TOLEDO - LUCAS COUNTY PLAN COMMISSIONS

DATE: September 12, 2022
REF: SUP-7005-22

SUBJECT: Amendment to Special Use Permit, originally granted by Ord. 409-13, for building addition to school

SITE PLAN

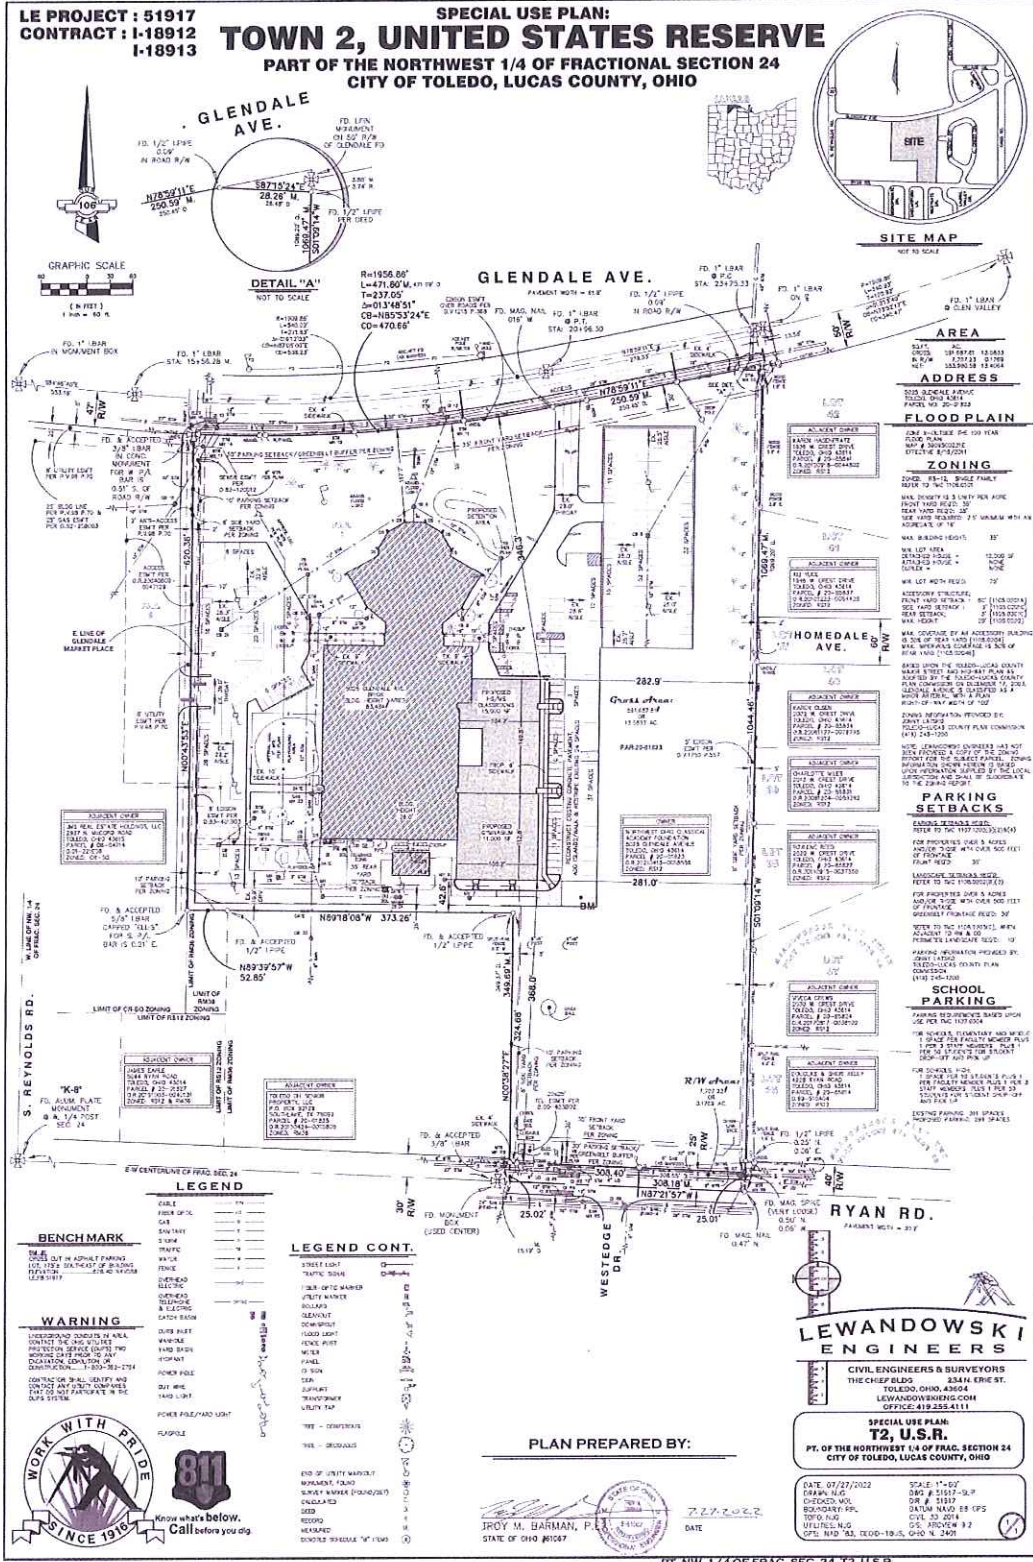
The site includes an existing parking lot with 361 parking spaces. Due to the addition, this number will be reduced to 299 spaces. Schools require one (1) parking space for each faculty member, plus one (1) space per three (3) staff members, plus one (1) space per fifty (50) students for pick up and drop off. High schools also require one (1) space per ten (10) students in addition to the standard school requirements.

The school plans on having sixty-eight (68) faculty and 700 students total, with fifty-two (52) to fifty-four (54) students per grade. The total number of parking spaces required per the TMC§1107.0304 requirements is 104, and the maximum allowed is 156. The applicant expects a total of 193 to 218 parking spaces needed for faculty, students, and student events. As the number of existing parking spaces is being reduced, the applicant's alternative parking plan is acceptable.

Per TMC§1107.1701 – *Number of Required Parking Spaces for Persons with Disabilities* site requires at least six (6) auto-accessible spaces and one (1) van accessible space. No modifications to the accessible parking are proposed and the site has adequate accessible parking. The site plan shows at least twelve (12) accessible spaces with either five foot (5') or eight foot (8') abutting aisles adjacent to them.

Bicycle parking is required pursuant to Off-Street Parking Schedule "A" (TMC§1107.0300). A minimum of one (1) bicycle space shall be provided per three (3) students, plus one (1) space per ten (10) parking spaces for faculty and staff. No more than fifty (50) bicycle parking slots are required per TMC§1107.0901(C). A bicycle rack for fifty (50) bicycles shall be provided on a revised site plan.

29. Per TMC§1107.0400, Off-Street Parking Schedule "A" requires one (1) bicycle parking slot per ten (10) parking spaces. **Not acceptable as depicted. Applicant shall provide a bicycle rack with fifty (50) spaces.**

LANDSCAPE PLAN

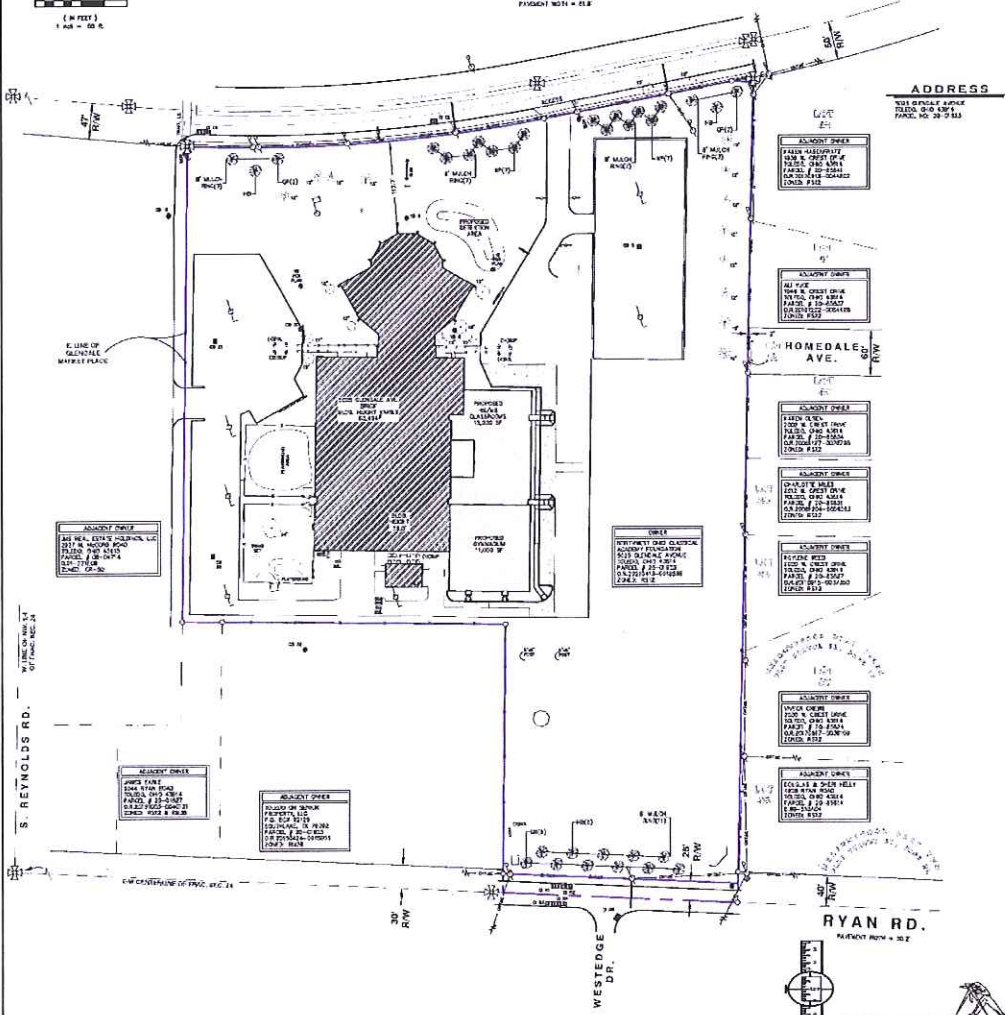
Per TMC§1108.0202 – *Frontage Greenbelts*, sites over five (5) acres are required to provide a thirty-foot (30') frontage greenbelt and contain at least one (1) tree for every thirty feet (30') of frontage. The submitted landscape plan depicts a thirty-foot (30') frontage greenbelt along Glendale Avenue and along Ryan Road. The Glendale Avenue greenbelt includes four (4) existing trees to remain which are credited per TMC§1108.0407(1)(B), and count as twenty-four (24) trees due to their caliper. The Glendale Avenue frontage greenbelt requires twenty-five (25) trees. The landscape plan depicts an additional twenty (20) trees along Glendale Avenue to further beautify the site. The Ryan Road greenbelt includes eleven (11) new trees and also meets the greenbelt requirement.

A Type B Landscape Buffer is required where RS-Single Family Districts abuts RM-Multifamily Districts. The nursing facility to the south is Zoned RM36-Multifamily Residential, and a Type B Buffer is required. A Type B Buffer requires four (4) canopy trees and fifteen (15) shrubs per 100 linear feet. There is an existing fence which may substitute for the shrub requirement. A revised landscape plan depicting at least twenty-eight (28) trees where the subject site abuts the nursing facility is required as a condition of approval.

- b. A Type B Landscape buffer is required where RS-Single Family Districts abut RM-Multifamily Districts. A Type B buffer requires four (4) canopy trees and fifteen (15) shrubs per 100 linear feet. Fencing may substitute for the shrub requirement; **not acceptable as depicted, a total of twenty-eight (28) canopy trees shall abut the nursing facility property to the south.**
